**Local Government Official Information & Meetings Act 1987 Request:**

*All communications between Timaru District Council and NuMat/Creo regarding the safety matting issues at Caroline Bay Playground, including any discussions around potential faults, repairs, or concerns about the matting's compliance with safety standards.*

*A copy of any audits and reports - third party or by Timaru DC on the Caroline Bay playground equipment and matting, including any findings, recommendations, or assessments related to the matting's condition and compliance with playground safety standards.*

### Safety Surfacing Remediations – Cplay

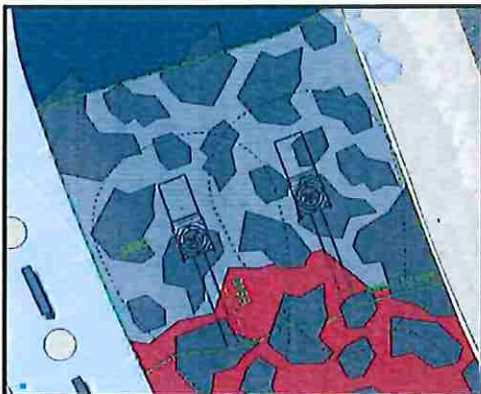
The shock pad thickness is correct in this area. We suspect that the recycled rubber included in the original shock pad is causing the issue. Additional shock pad and another top layer will be applied in grey tones. The area will be slightly raised to accommodate this as discussed onsite.

### Area 3 – High Swing

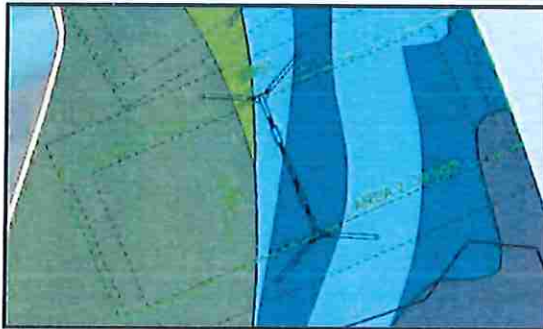
It was found that the drawings were incorrect and that the wrong shock pad thickness was specified for this area. Additional shock pad and another top layer will be applied in a similar design. The area will be slightly raised to accommodate this as discussed onsite.

#### Area 2 – Ninja Wall

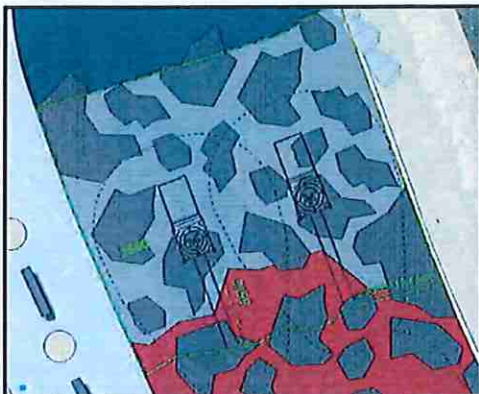
The shock pad thickness is correct in this area. We suspect that the recycled rubber included in the original shock pad is causing the issue. Additional shock pad and another top layer will be applied in grey tones. The area will be slightly raised to accommodate this as discussed onsite.

**Area 3 – High Swing**

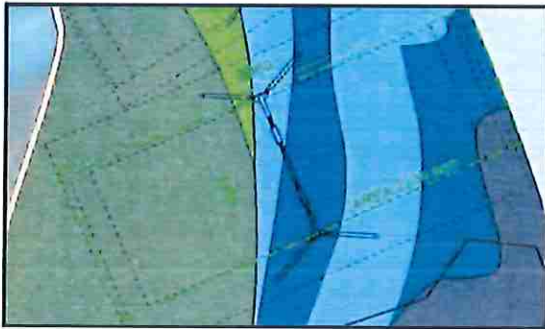
It was found that the drawings were incorrect and that the wrong shock pad thickness was specified for this area. Additional shock pad and another top layer will be applied in a similar design. The area will be slightly raised to accommodate this as discussed onsite.

Figure 8 — Example for rounded side profile (Note in this example – the edges of the animal do not need to meet the 20mm requirement)

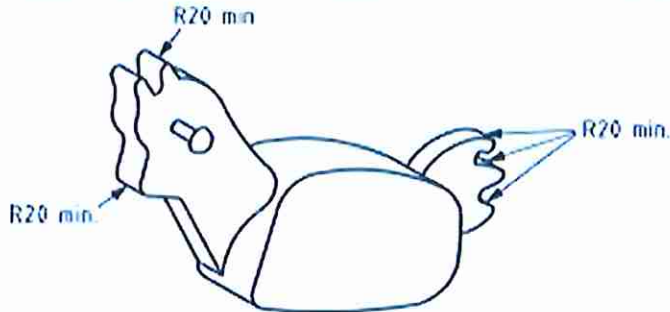
Disagree with the body of the horse having to meet 20mm radius. 3mm should be sufficient.

#### Finding 10

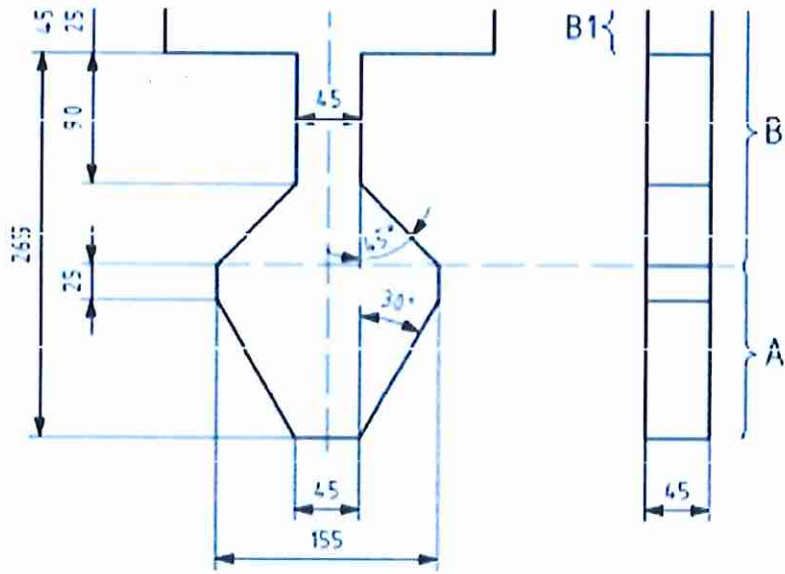
Disagree – fall from each step is less than 600mm and no different from stairs or steep play leading to deck.

#### Finding 12

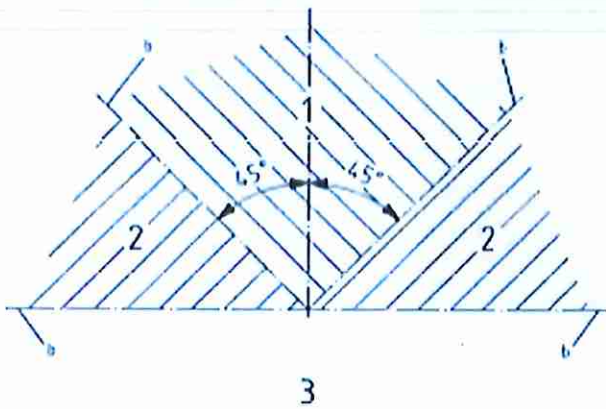
Considering Adam's recommendation of closing the gap to 45mm, I feel that Adam has not applied the range 2 rule correctly to this scenario. The depth needs to be 120mm or more to fail. There is no evidence in his report that he tested this

Opening is Partially bound, Procedure Applies.

Finding 13

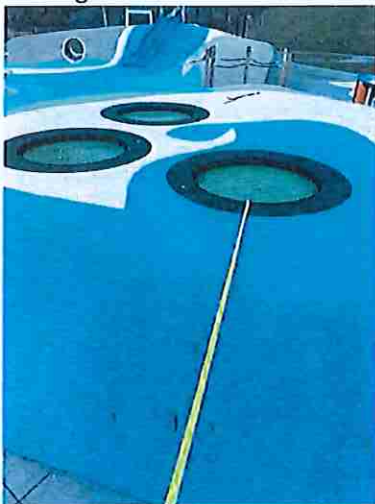
4.2.7.5 entrapment of foot - surfaces intended for running/walking. this tunnel is intended for crawling.

Finding 15 – Correct, I didn't spot this. A small wedge would mitigate.

Finding 14

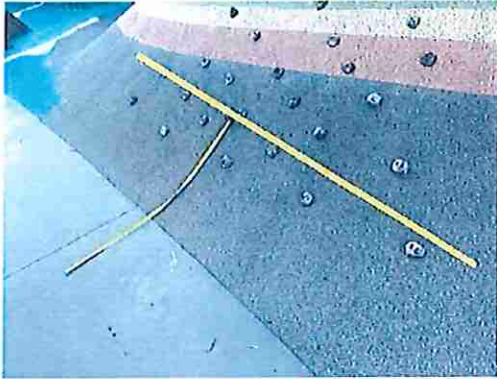
There is no rule in the 5828:2015 standards regarding trampolines. See certified equipment requirements by supplier/manufacturer for fall space requirements.

Question impact attenuation of plastic – fall from height of tunnel, not top of mound - ground level.

This rule only applies to attachment slides with a fall height greater than 1m. This is an embankment slide.

#### Finding 27

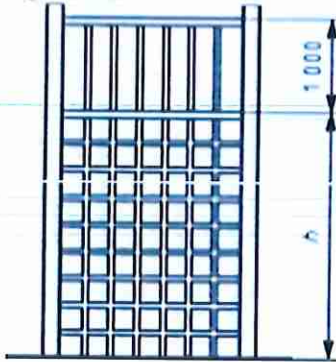
Not a failing in the standard. no measurement given on width of barriers. Adams finding is opinion. No horizontal railings to encourage sitting.

No vertical fall above 600mm. Child can stand up.

Disagree with adams measurement of fall to blunt support - This distance is a hand hold minus 1m to support bar, so the distance of the fall to impact is 640mm. if measured correctly. EN 1176.1:2008 figure 14.

This is 4cm over the limit of fall within a play structure if Adam's measurement to full height is correct.

Finding 58

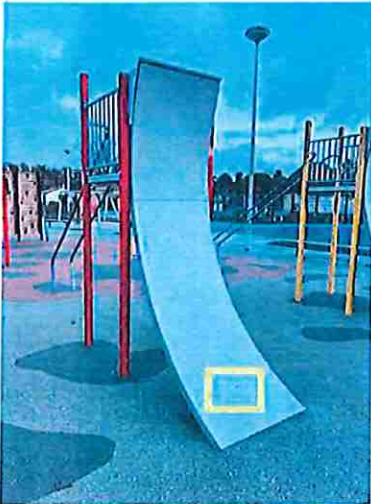
Disagree with Adams finding - The purpose of the finger entrapment ruling is to stop fingers getting caught during forced movement. The definition of forced movement can be argued for this equipment. I think common sense prevails in this situation, considering movement ceases on the ground.

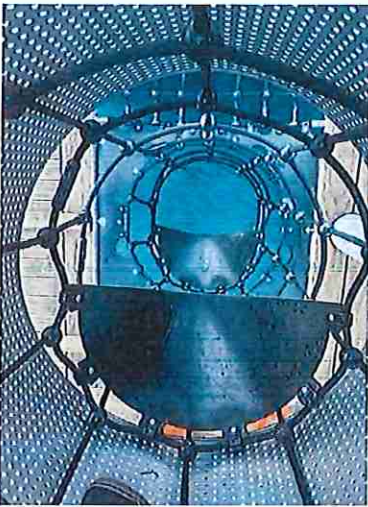
Adam wrote "Slide Type 1 -The slide run-out should be surrounded by an impact attenuating area that extends at least 1.0m on each side and at least 2.0m in front. This impact area should be free from any overlapping falling"

Doesn't say this in the standards.
